ATTACHMENT A

APPLICATION FOR AMENDMENT
TO TECHNICAL SPECIFICATIONS

AEC Docket No. 50-247

October 7, 1974

FIG. 6.2-1 NUCLEAR POWER GENERATION DEPT.

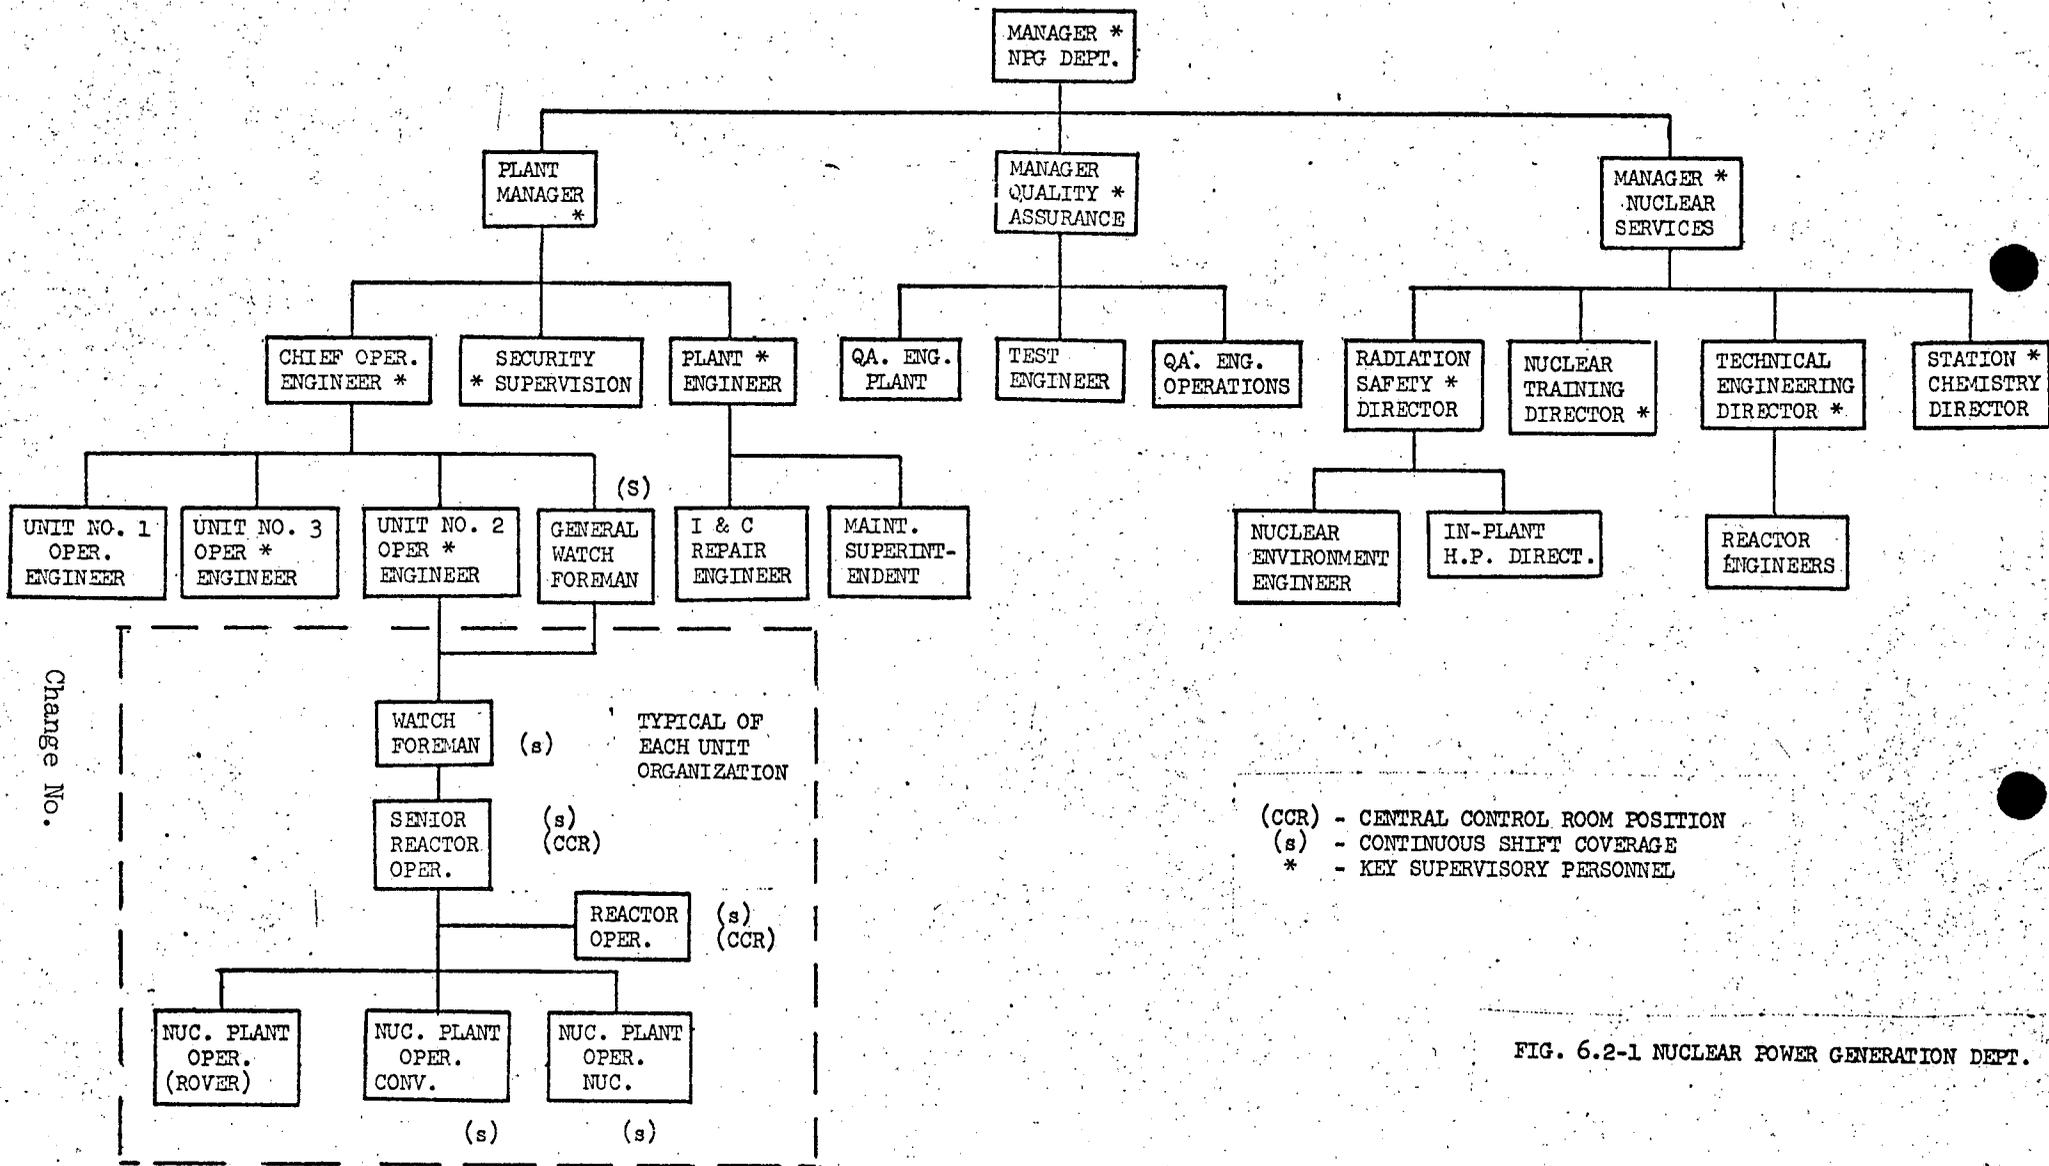
Consolidated Edison requests a rewording of the parts of Section 6 (Administrative Controls) that involve the organization of the Nuclear Power Generation Department. Because of a planned reorganization of this Department, revisions of Pages 6.1-1, 6.1-2, 6.2-1, 6.5-1, 6.5-12 and Figure 6.2.1 are requested. These changes would specify the positions of the persons responsible for operations of the plant in accordance with the AEC requirements. Furthermore, we propose that Figure 6.1-1 be deleted from the Technical Specifications.

6.2.1 The Station staff organization shall be as shown in Figure 6. 2-1 and shall function as follows:
